# Colibri iMX6

## Errata Document

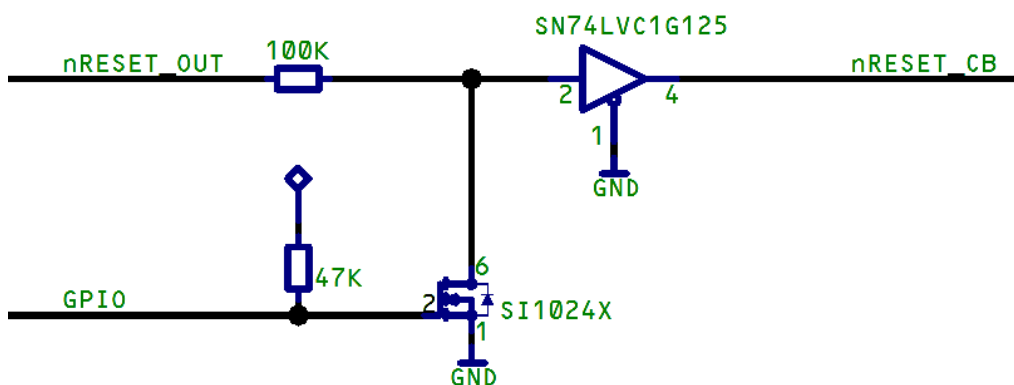
During a software initiated reset cycle, the nRESET\_OUT signal is not asserted on the Colibri iMX6 V1.0 module. Unlike other Colibri modules, the nRESET\_OUT signal remains the whole time high during the software initiated reset.

During power up as well as hardware initiated reset cycles (by pressing the nRESET\_IN/RESET\_EXT button), the nRESET\_OUT signal gets asserted similar to other Colibri modules. This is not an issue as long as external peripheral devices on the carrier board do not need to be reset during a software reset or no software initiated reset cycles are used on a system.

A possible workaround is implementing a small reset circuit on the carrier board that allows driving low the reset signal by using any free GPIO:

Since on the Colibri iMX6 the reset state of regular GPIOs is configured as input with enabled internal pull up resistor, the transistor will pull down the reset line during a software initiated reset cycle. The bootloader or application needs to reconfigure the GPIO as output and drive it low for releasing the external reset signal.
